APPLICATION NO.	FILING DATE	FIRST NAMED INVENTOR	ATTORNEY DOCKET NO.	CONFIRMATION NO.
10/673,777	09/29/2003	Volkert A. Zeijlemaker	P-10499.00	2479

Office Action Summary	Application No. 10/673,777	Applicant(s) ZEIJLEMAKER ET AL.	
	Examiner John F. Ramirez	Art Unit 3737

DETAILED ACTION

FIG.5

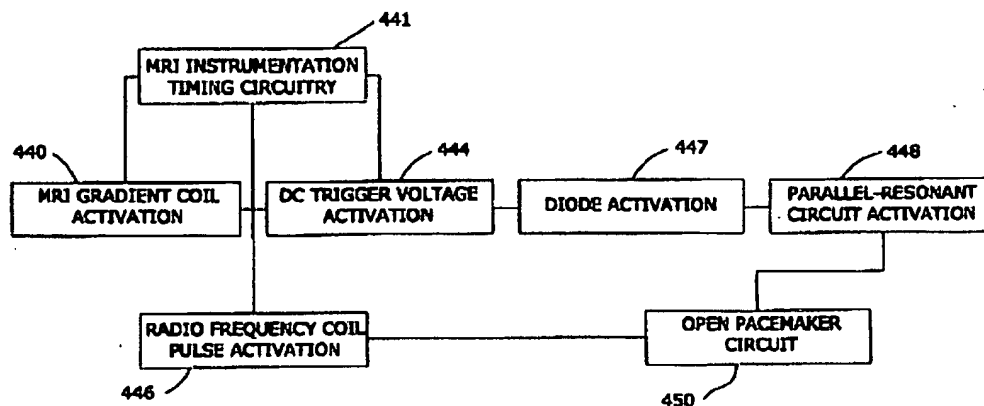
Foster et al. discloses a magnetic resonance imaging (MRI) device comprising: a magnet to generate a magnetic field (col. 1, lines 24-41); an electromagnetic radiation source to apply electromagnetic radiation bursts (col. 1, lines 24-41); an imaging unit to generate images of patient following application of radiation bursts (col. 8, lines 37-55); a receiver to receive information from an implantable medical device (IMD) (abstract); and a control unit to coordinate application of the electromagnetic radiation bursts based on the information (see Figure 5), the information defines a timing of stimulation pulses applied to a patient with the IMD, in which the received information defines a timing of the stimulation applied to the patient by the IMD (col. 7, lines 5- 67).

With respect to claims 8 and 9, Foster et al. shows in Figure 5 performing an MRI includes applying one or more electromagnetic radiation bursts and applying one or more gradient magnetic fields based on the information.

Figure 3

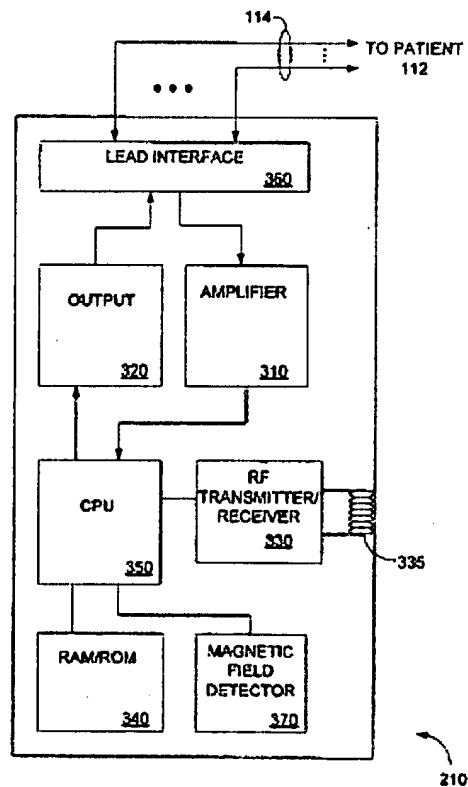
Terry et al. shows in Figures 1-3, an implantable medical device (IMD) (110) with a control unit (col. 3, line 48-50) to coordinate application of magnetic resonance

imaging (MRI) electromagnetic radiation bursts with operation of an implantable medical device (col. 3, line 48 – col. 4, line 44); and a transmitter (330) to transmit information to the IMD to cause the IMD to operate in coordination with an MRI device (col. 3, line 48 – col. 4, line 44), the medical device comprises a programmer for the IMD (Figure 3) and an MRI system, further comprising stimulating the patient with the IMD to induce an arrhythmia during the MRI (col. 5, line 21- col. 6, line 4).
